**HERMOSA TOWN BOARD
WORK SESSION/SPECIAL MEETING
OCTOBER 8, 2024
5:30 PM**

- 4) **WORK SESSION ITEMS:**
 - A. Permit 2024-33 – Subdivision Plat/Floodplain – Parcel 004139
 - B. Permit 2024-35 – Floodplain Application – shed in Floodway
 - C. Live Stream Cameras – Aaron Serviss

**A PLAT OF
BARRIER TRACTS 1 THRU 4 OF McDERMAND
SUBDIVISION, LOCATED IN THE SE1/4 NW1/4 OF SECTION
32, T2S, R8E, BHM, CUSTER COUNTY, SOUTH DAKOTA
FORMERLY LOT DALE AND VACATED PORTION OF MCDERMAND ST.**

Staff Report includes a recommendation to disapprove of the proposed plat. The purpose of this report is to clarify the facts and technical merits regarding the floodplain associated with the proposed plat. Information in Staff Report makes a strong case that the Ferguson Subdivision should not be platted but does not support the recommendation to disapprove the plat of Barnier Tracts 1 through 4.

**A PLAT OF
BARRIER TRACTS 1 THRU 4 OF McDERMAND
SUBDIVISION, LOCATED IN THE SE1/4 NW1/4 OF SECTION
32, T2S, R8E, BHM, CUSTER COUNTY, SOUTH DAKOTA
FORMERLY LOT DALE AND VACATED PORTION OF McDERMAND ST.**

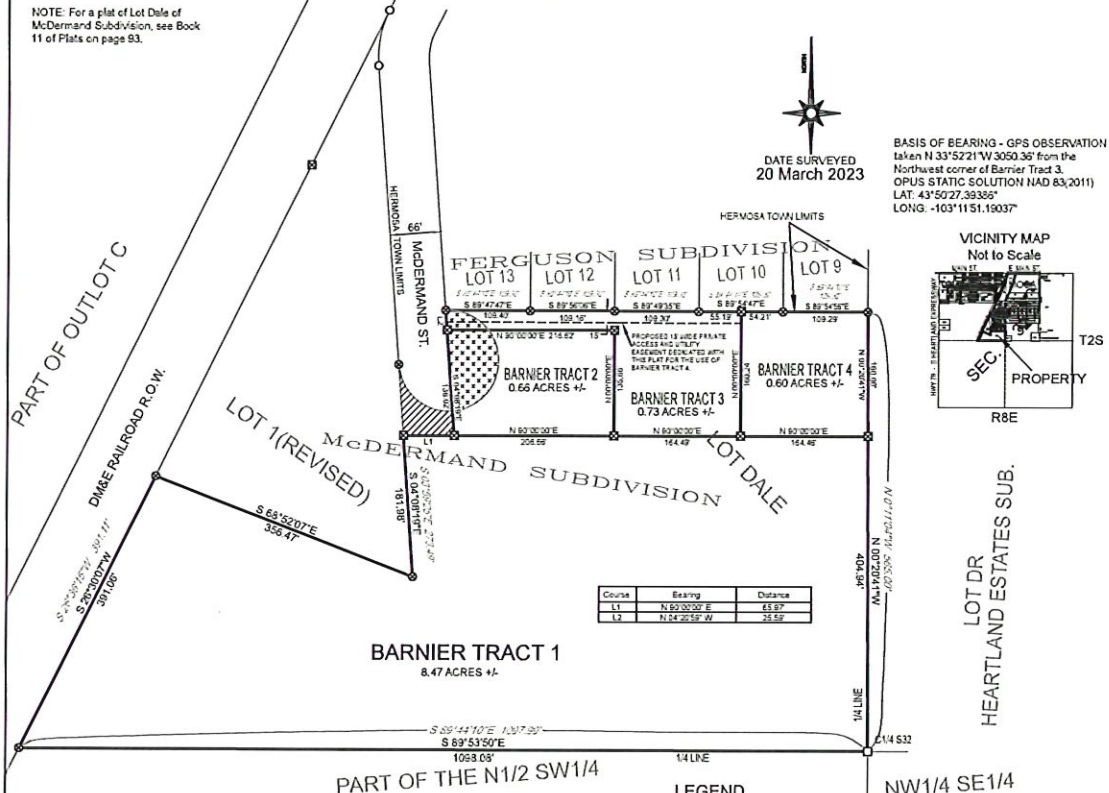
1. The proposed plat of Tracts 1 through 4 of McDermand Subdivision will all continue to have access by McDermand Street. This is consistent with the current Street Plan for the Town, with development in the adjoining residential neighborhood and complies with state law. (*SDCL 11-3-6*)

- a. Proposed Tracts **#1, #2, and #3** adjoin McDermand Street. This access to McDermand Street meets the access requirements of the Subdivision Ordinance, section #154.22(A) (1,3).

- b. Proposed Tract **4** has access to McDermand Street by a Private Access Easement, located along the north edge of Tract 3. This access to McDermand Street meets the Private Access requirements of the Subdivision Ordinance sections #154.02 (Streets) (4); and #154.35(K).

2. The proposed plat of Tracts 2 through 4 of McDermand Subdivision will be served by the municipal water system. Lot Dale has had Town water service since late 2014. This is required by Town Ordinance section #50.01(A) and state law.

3. The proposed plat of Tracts 2 through 4 of McDermand Subdivision will be served by the municipal sewer system. Lot Dale has had Town sewer service since late 2014. This is required by Town Ordinance section #51.02(C) (2) and state law.

4. The proposed plat of Tracts 1 through 4 of McDermand Subdivision will all exceed the minimum lot area of 7500 square feet required for the RS zoning district; #155.30(D) (4)

5. The proposed plat of Tracts 2 through 4 of McDermand Subdivision will have a 20 foot wide utility easement centered on shared lot lines and a 10 foot easement on each exterior lot line. This meets Ordinance sections #154.23(D) and #154.38 (A) and (B), and is consistent with development in the adjoining neighborhood.

6. The proposed plat of Tracts 2 through 4 of McDermand Subdivision will have a drainage easement 20 feet wide centered on each shared lot line and 10 foot wide on each exterior lot line. This follows Ordinance sections #154.23(D) and #154.38(A) and (B), and is consistent with development in the adjoining residential neighborhood.

Staff Report, 259 Donna St.
October 10, 2016

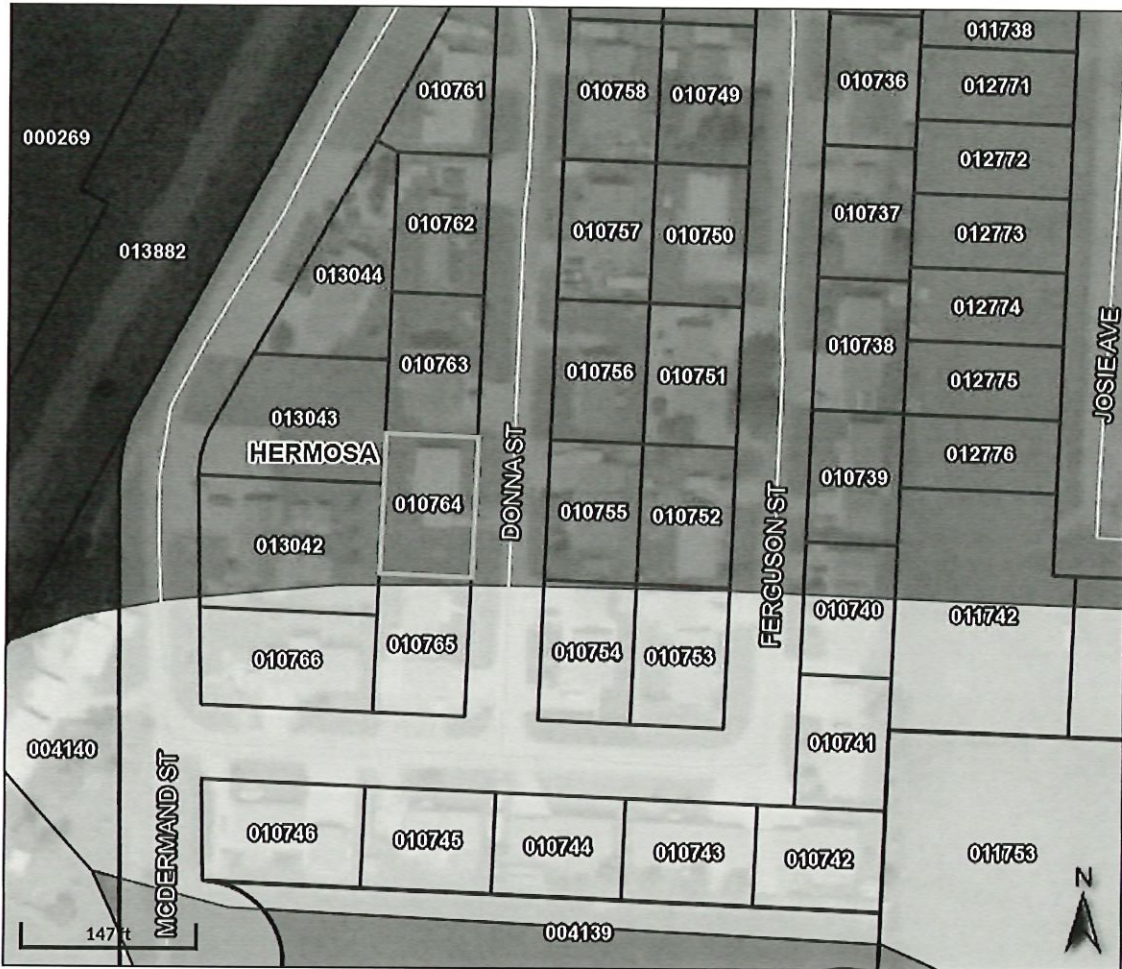
The site plan submitted by the applicant illustrates that the building would obstruct a portion of the floodway. This represents a significant obstruction to the limited area between existing buildings through which water must flow during a flooding occurrence.

Encroachments are prohibited, including fill, new construction, substantial improvements and other development within the adopted regulatory floodway *unless* it has been demonstrated through hydrologic and hydraulic analyses performed in accordance with standard engineering practice that the proposed encroachment would not result in any increase in flood levels within the community during the occurrence of the base flood discharge.

The application does not include any hydraulic analysis as required by Section 151.19 of the Flood Damage Prevention Ordinance. The application should therefore be denied until a hydraulic analysis is submitted showing that the proposed encroachment would not result in any increase in flood levels within the community during the occurrence of the base flood discharge. It is unlikely that an analysis can be performed that will show no increase in the BFE due to the size of the obstruction to the Floodway.
